**RESTRICTIVE COVENANT AMENDMENT REVIEW SHEET**

**CASE:** C14-91-0015(RCA)  
Champion Commercial Development

**Date:** February 7, 2011  
**To:** Clark Patterson, Case Manager  
**CC:** Kathy Hornaday, P.E., PTOE  
HDR Engineering, Inc.  
**Reference:** Champion Commercial Development, C14-91-0015(RCA)

Roadway Exhibit

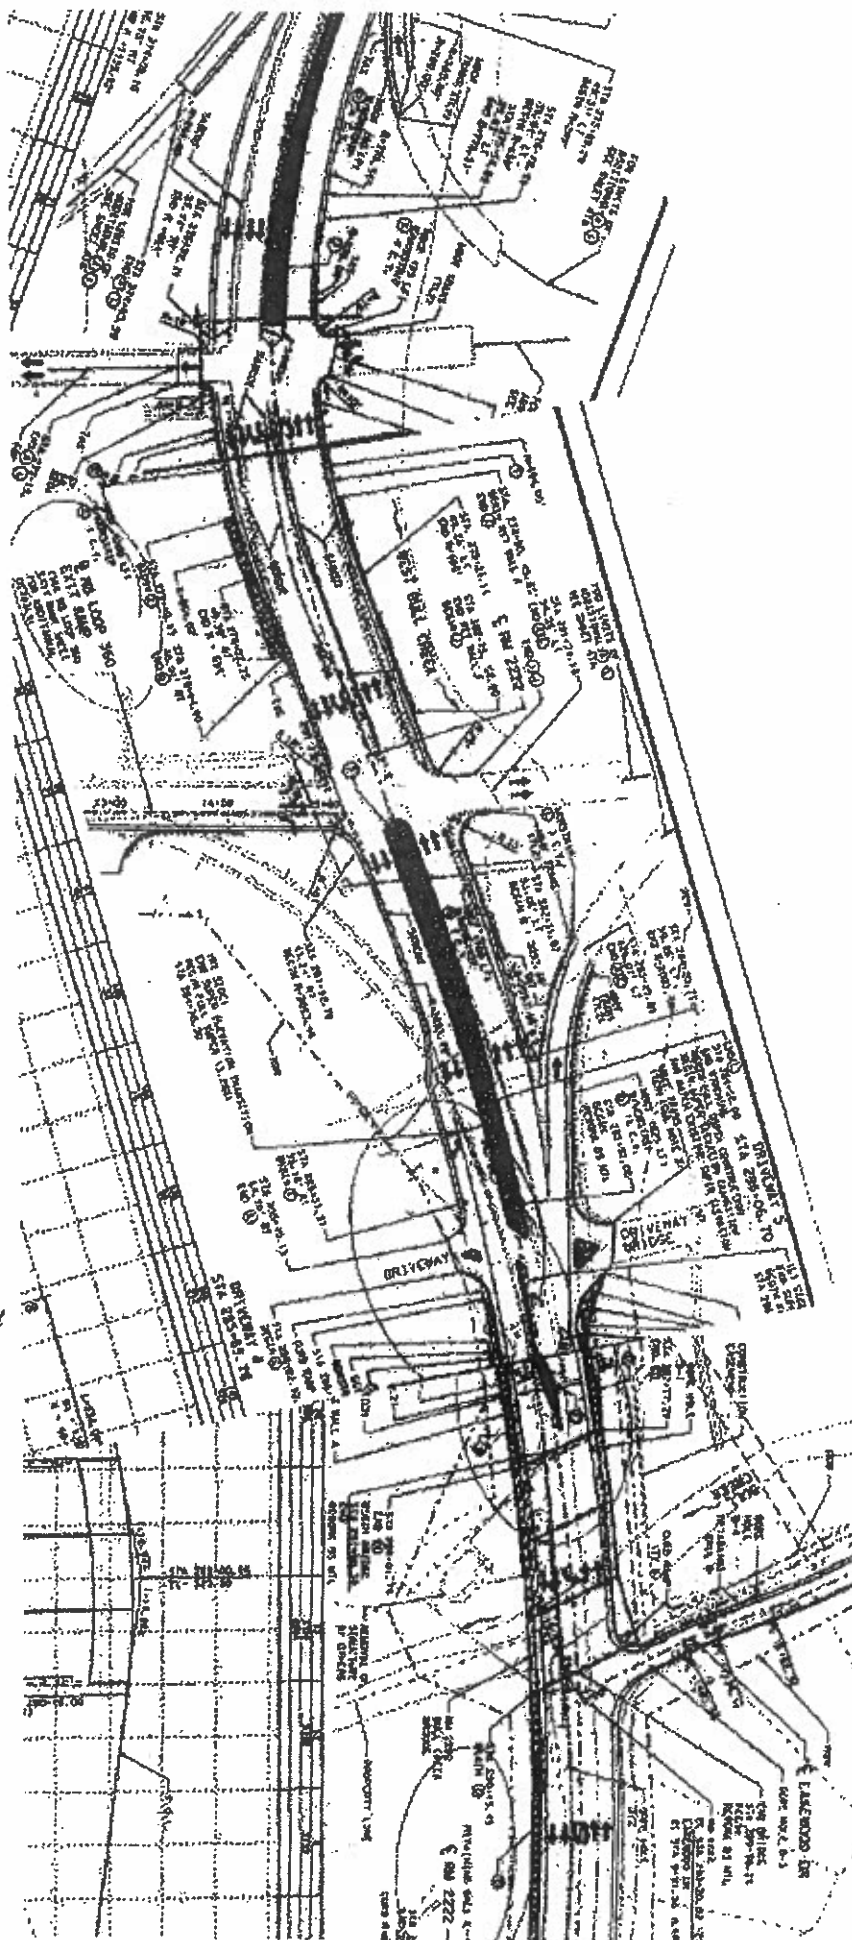
The Texas Department of Transportation (TXDOT) is currently reconstructing RM 2222. The reconstruction project includes widening of RM 2222, a left-turn lane for eastbound traffic turning onto Lakewood Drive, and removal of the dedicated right-turn lane from northbound Capital of Texas Highway to eastbound RM 2222. A signal will also be installed at Lakewood Drive and RM 2222. The widening of RM 2222 will provide sufficient width to accommodate a left turn lane into this site from RM 2222 (See Exhibit A – Roadway Exhibit).

- 1) Left-turn access into the site from westbound RM 2222 is recommended for this site. Roadway and driveway improvements should be provided in accordance with the assumptions in the TIA update.

**Figure 1**  
**RM 2222 Proposed Lane Configuration**

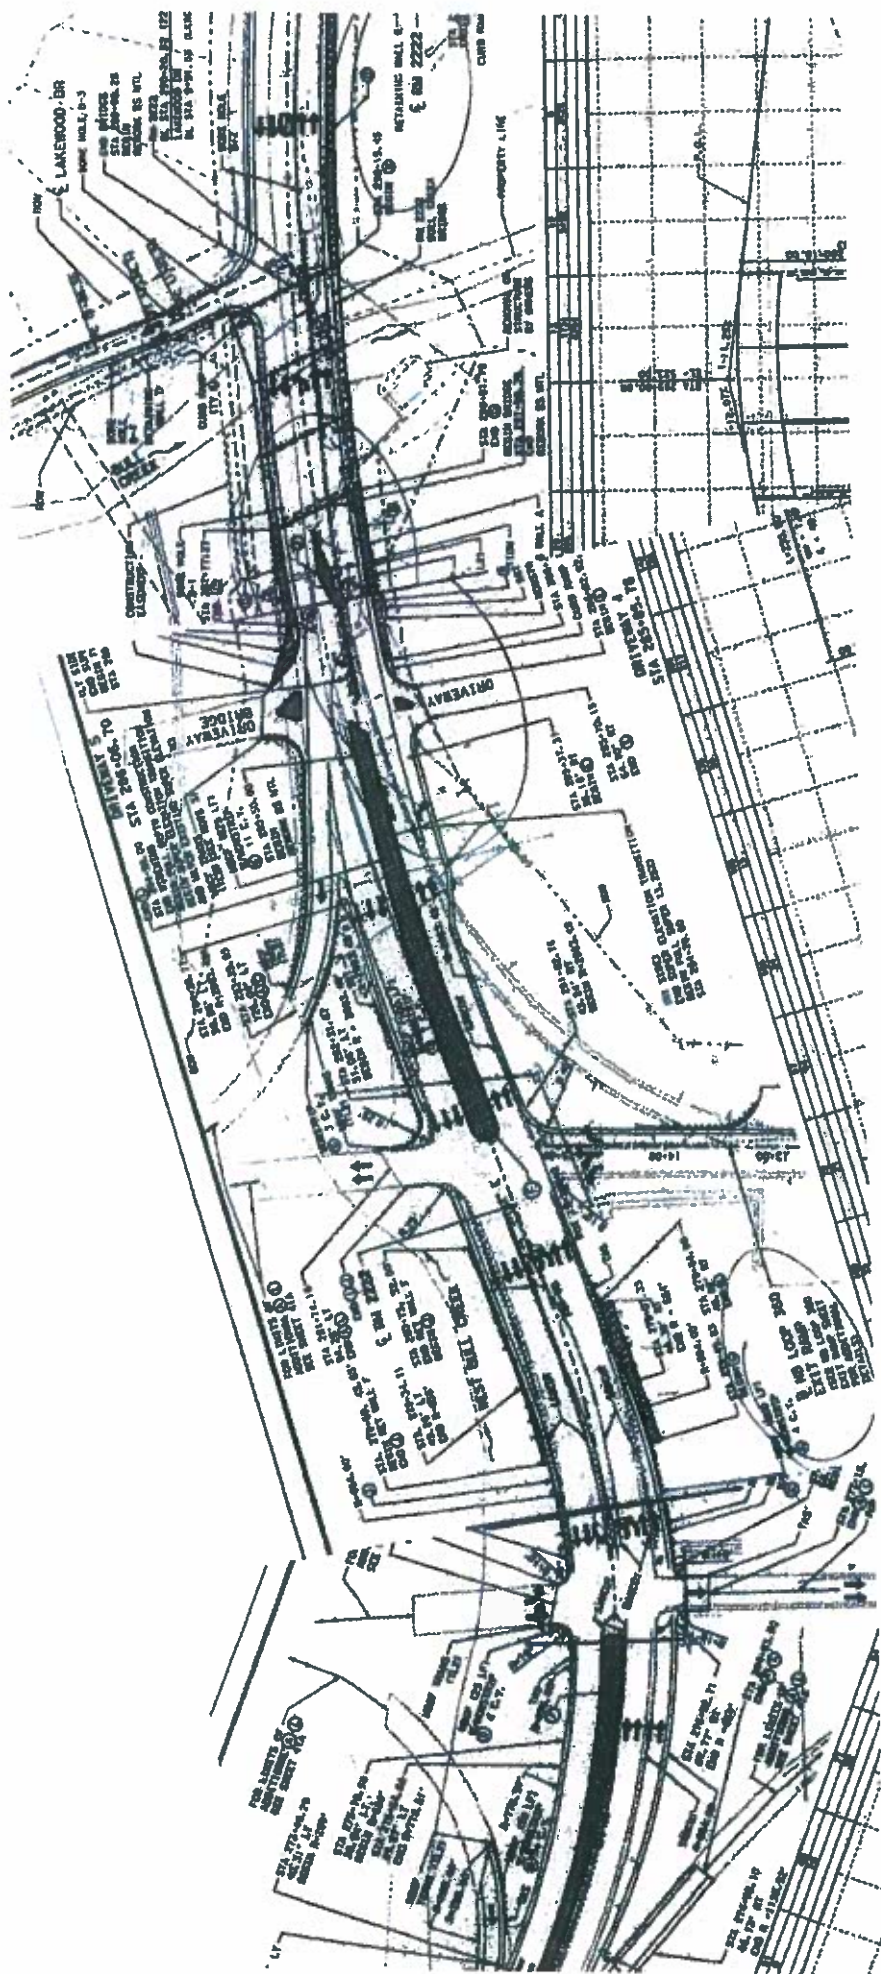
As shown in Figure 1, the Champion Tract driveway on RM 2222 will be aligned with an existing driveway to a retail center on the north side of RM 2222. This driveway is a right-in/right-out only driveway. Counts were not available for this location; therefore, traffic to and from this retail center was estimated given the land use present on the site, which includes 14,600 square feet of quality restaurant, 8,330 square feet of high turnover restaurant, and 4,070 square feet of shopping center. (Trip generation information is enclosed.) The retail center also has an access driveway (not depicted) on Loop 360 Northbound Frontage
